SHOP DOPE BULLETIN NO. 398

2-14-58

BRAKE DRUMS AND SHOES, DUO-GLIDE MODEL

CAST IRON BRAKE DRUM
(new for parts order)

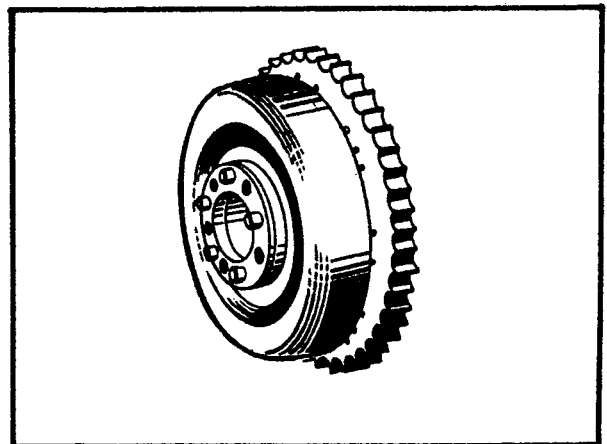
Duo-Glide motorcycles shipped from the factory after November 21, 1957, incorporate a change in the rear wheel brake drum and shoes. This change was also made on Sidecar wheel brake drum and shoes beginning January 9, 1958. Brake drum material was changed from pressed steel to cast iron, and a corresponding change was made in brake shoe lining material to provide proper friction with cast iron brake drum surface.

Part No. 41400-58A (with sprocket)
Part No. 41402-58 (less sprocket)
Part No. 87657-58A (sidecar)

Part No. 41801-58 Brake Shoe Set
(Parts order shoes painted GREY)

PRESSED STEEL BRAKE DRUM
(no longer supplied for parts order)

Part No. 41400-58 (with sprocket)
Part No. 41401-58 (less sprocket)
Part No. 87657-58 (sidecar)

Part No. 41800-58 Brake Shoe Set
(Parts order shoes painted BLACK)

Only cast iron brake drums will be supplied on parts order. When a pressed steel brake drum requires replacement, order and use new brake shoe set, part No. 41801-58 with new cast iron brake drum supplied. Also, use these new brake shoes when servicing late Duo-Glide Motorcycles or sidecars already equipped with cast iron brake drums. (Cast iron brake drum is easily identifiable by 2 square lugs on outside surface as shown in above illustration).

Order and use old brake shoes, part No. 41800-58, for replacement on pressed steel brake drum only.

To insure correct brake operation, be sure to use parts as specified. Using brake shoes intended for pressed steel drums with cast iron drums, or using brake shoes intended for cast iron drums with pressed steel drums will cause incorrect braking action.
